ALERT SERVICE BULLETIN

412-24-197

- MODEL AFFECTED:** 412/412EP
- SUBJECT:** CAP ANGLE, P/N 212-030-191-001, SPECIAL INSPECTION INTERVAL, REDUCTION OF.
- HELICOPTERS AFFECTED:** **PART I:** Serial numbers 33001 through 33213, 34001 through 34036, 36001 through 36693.

Figure1. Fuselage Tailboom Attachment Inspection.

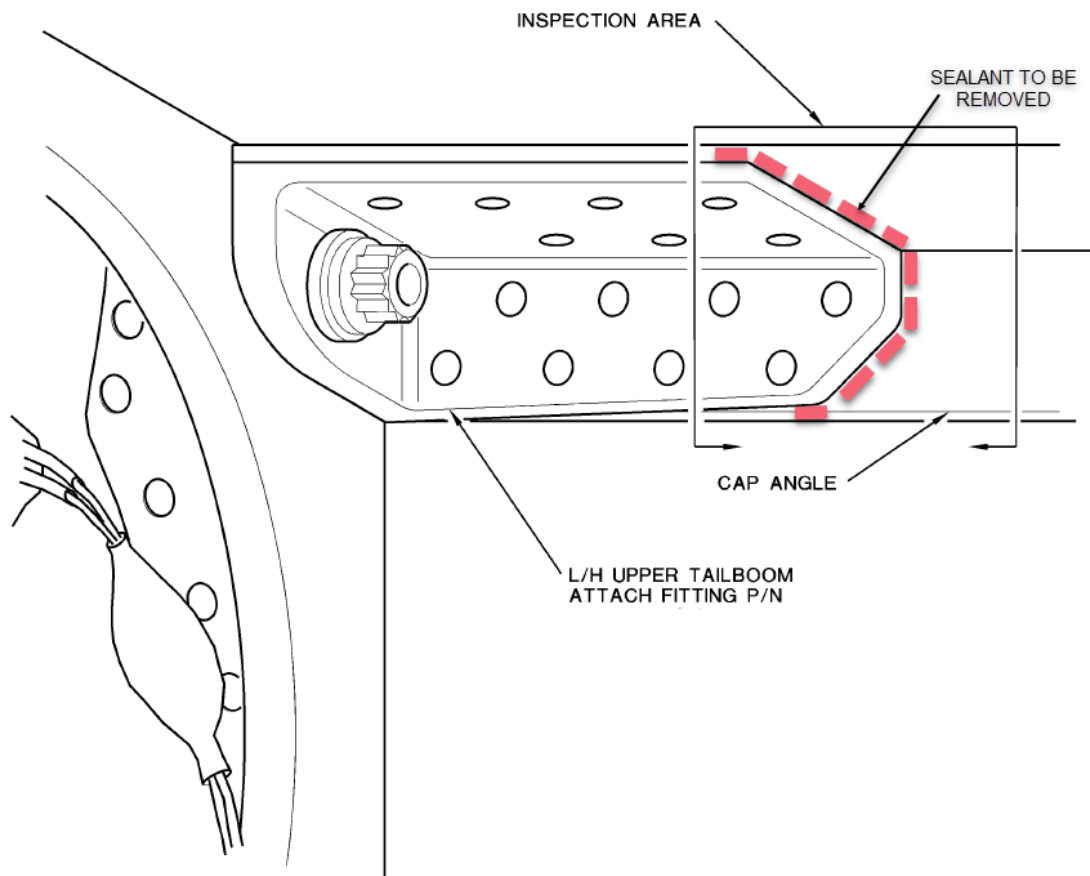
2. If sealant is present, remove sealant from edge of fitting (Figure 1).
3. Inspect the cap angle area shown with a 10x magnifying glass and bright light.

4. If a crack is found, replace the cap angle before further flight. If the helicopter is at a location where the cap angle cannot be replaced, contact Product Support Engineering.
5. Touch up primer if damaged during sealant removal. Paint touch up is optional. Do not reapply sealant.
6. If no cracks are found, the helicopter can be returned to service.
7. Make an entry in the helicopter logbook and historical service records indicating findings and compliance with this Alert Service Bulletin.
